**AMENDMENT NO. 2
TO THE
PROFESSIONAL ARCHITECT/ENGINEERING SERVICES
AGREEMENT
BETWEEN
THE TEXAS FACILITIES COMMISSION
AND
JACOBS ENGINEERING GROUP INC.**

**Subject: Additional Service Proposal – ASP 02
Austin Energy Dual Feed Modifications**

**Project: North Austin Complex
TFC Contract No.: 17-025-000**

Austin Energy Meeting

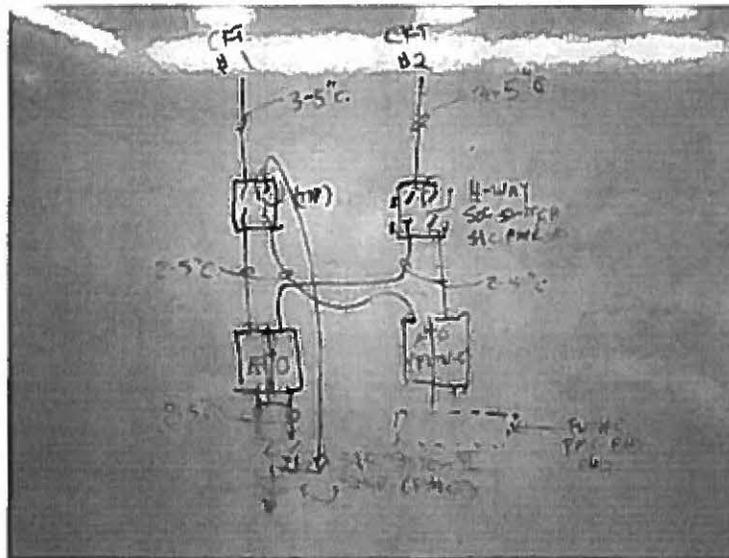
1. The proposed configuration for Phase 1 includes:
 - a. Two (2) primary circuits (KL-3 and JL-5) to two (2) separate four-way switches (S&C Model # PME-10). Each PME-10 requires a 6'x7' concrete pad.

- b. From each PME-10, a primary and secondary feeder will be extended to one (1) Automatic Throw-Over Switch (ATO) to be installed in Phase 1. The second ATO and its primary and secondary feeders will be deferred to Phase 2. Both ATO concrete pads (10'x10') will be installed in Phase 1.

- c. Two (2) feeders will extend from the Phase 1 ATO to a Primary Metering Cabinet (PMC).
 - d. Two (2) new riser poles will be installed at 51st St.
 - e. A ductbank along East Guadalupe, from 51st St. to the project site with 6 - 5" conduits. Two conduits will extend partially up each riser pole. The two (2) remaining spare conduits will terminate in the first manhole at 51st St. and be capped.

- f. The following picture indicates the proposed AE electrical installation described in items (a) through (c) above:
